APPENDIX D – Email response from SW to Andy Keen - 29.11.2018

From:	Admans-Palmer, Tim
To:	Ana Ruiz; Andrew Keen
Cc:	Mutalima, Rachel; Jordan, Adrian-Davies
Subject:	RE: Free Wharf, Shoreham-By-Sea - gravity connection proposals
Date:	29 November 2018 09:38:55
Attachments:	image001.png North East Gravity Connection to MH22052102.pdf

Free Wharf S98 SL2 Shoreham A259

North East Gravity Connection to MH22052

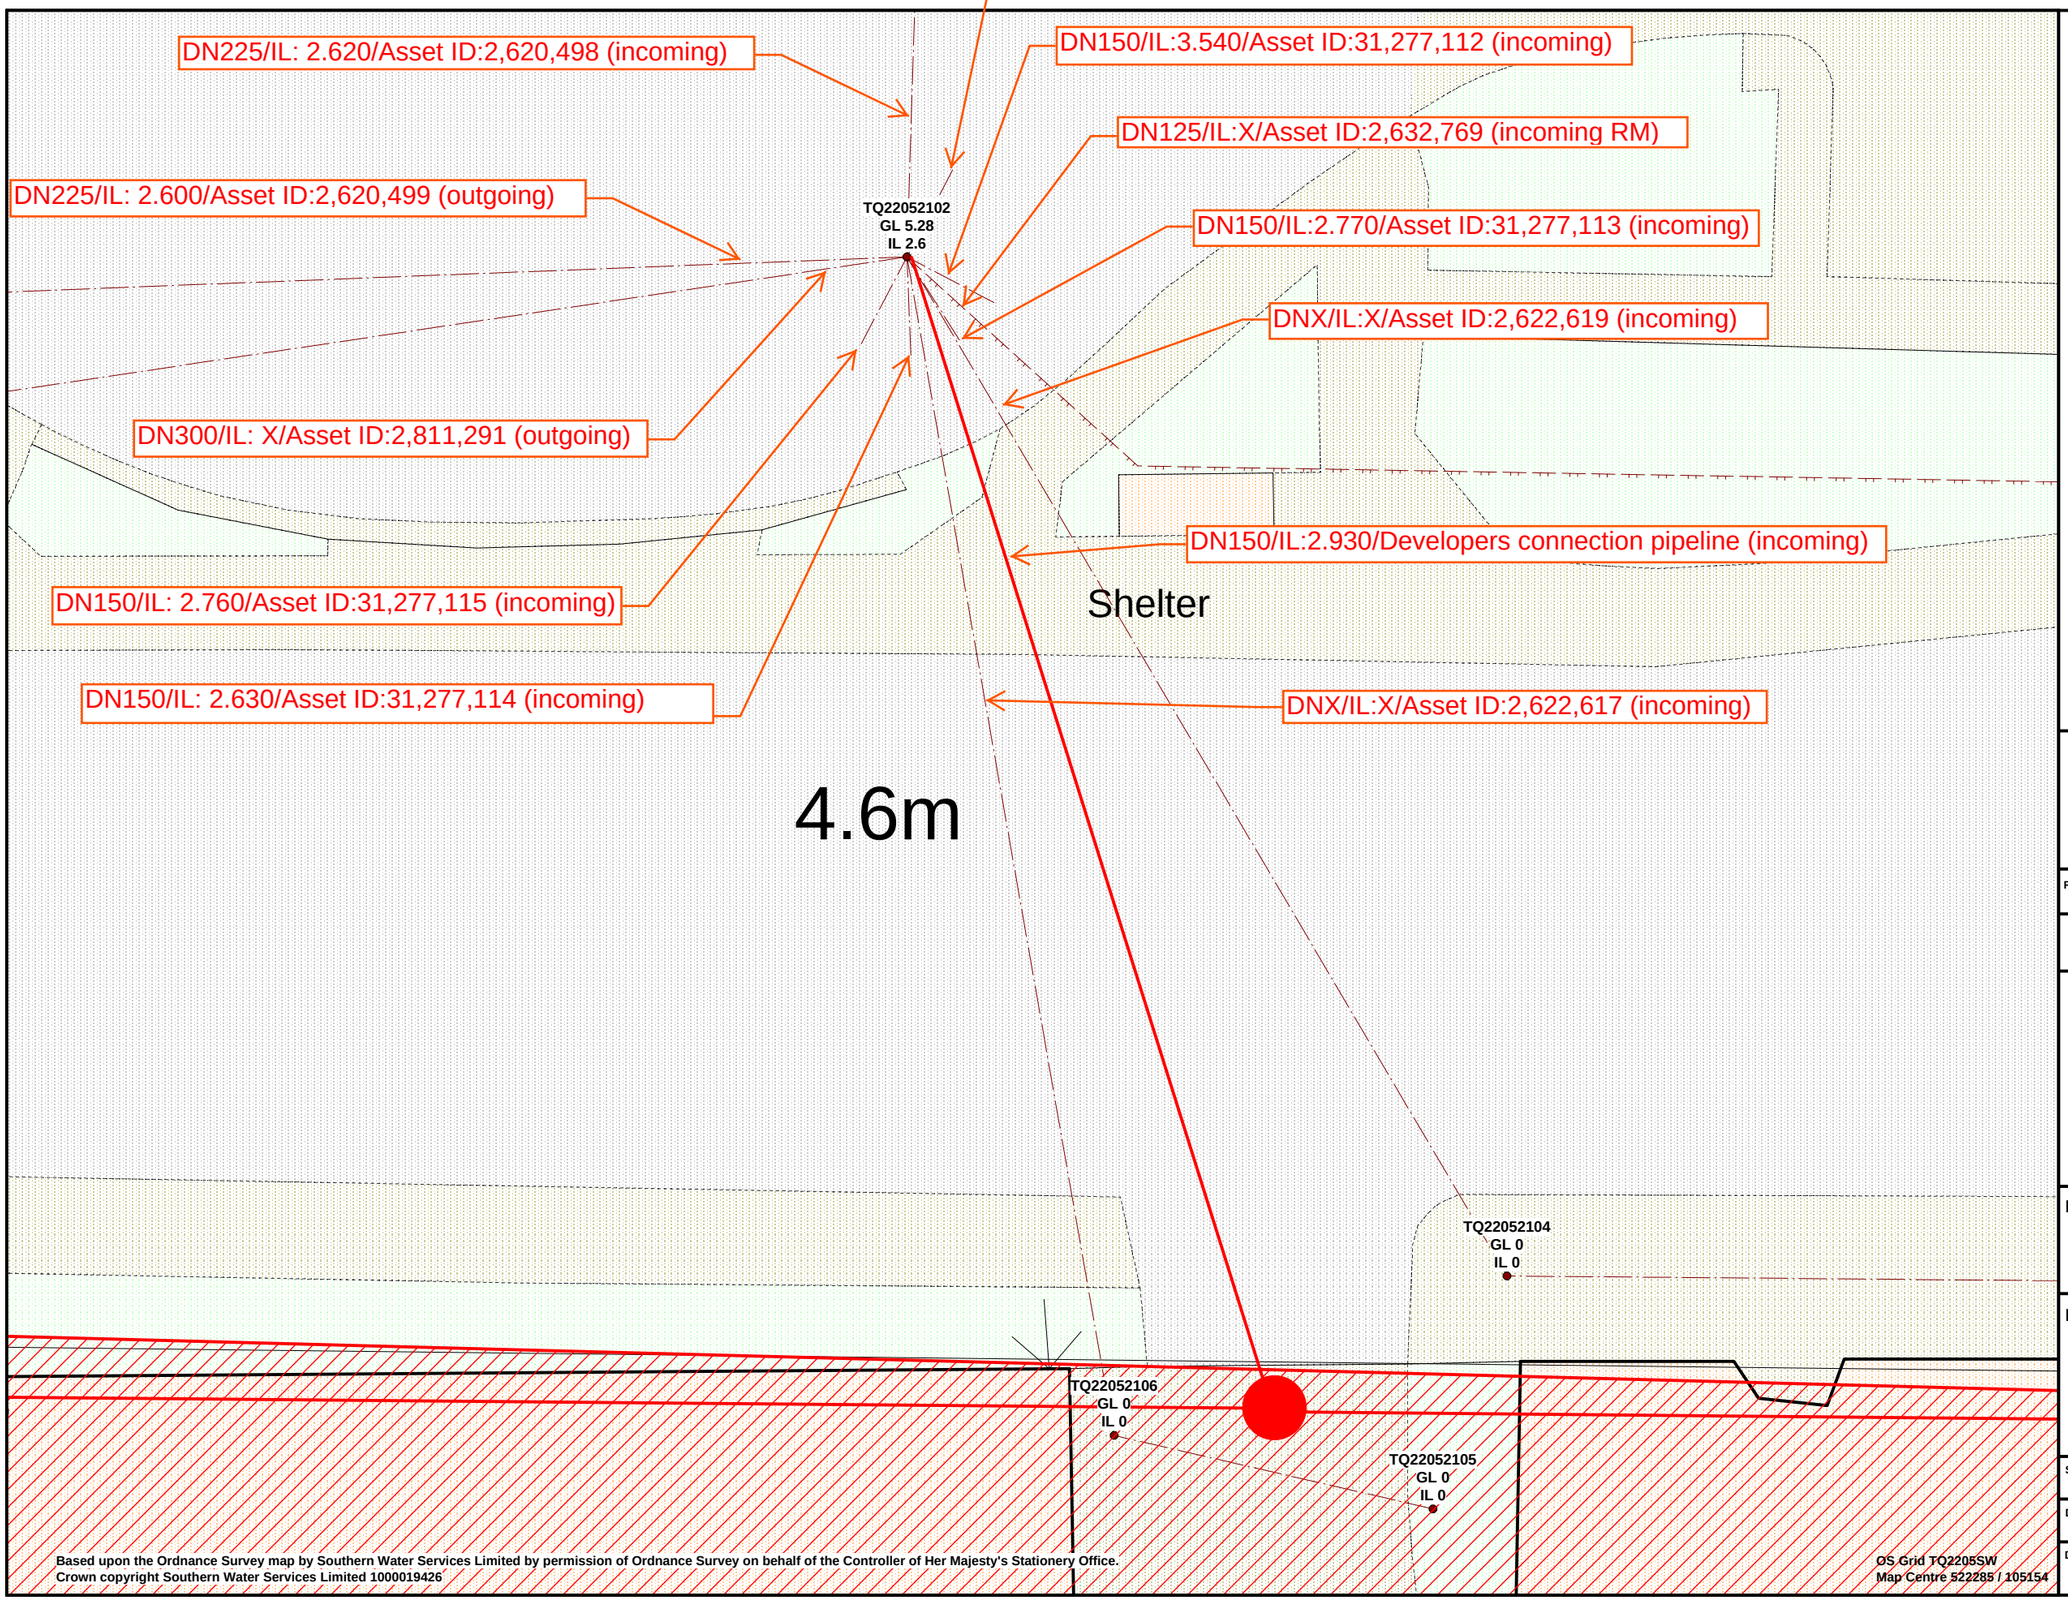
d. The attached pdf mark up of MH 22051102 is taken from SW's Mapinfo GIS and shows additional incoming gravity sewer pipes not present on the developer's

drawing. Also shown are the invert levels of the incoming pipes. The dimensions of the MH are unknown and the attached mark-up shows numerous incoming sewer pipes.

e. Based on item 2.d Adrian has amended the proposed invert level of the developer's incoming DN150 sewer pipeline to 2.93mAOD. This will produce a gradient of 1/100 on the DN150 sewer pipeline based on the IL of final MH on the Developers drainage plan (3.182 mAOD) and the approximate distance to MH22051102 (25m). Given the invert level of MH22051102 is 2.6mmAOD this should allow for connection of developers pipeline without clashing with the benching or existing pipelines. This does not preclude the potential need to upsize this MH at a later date.
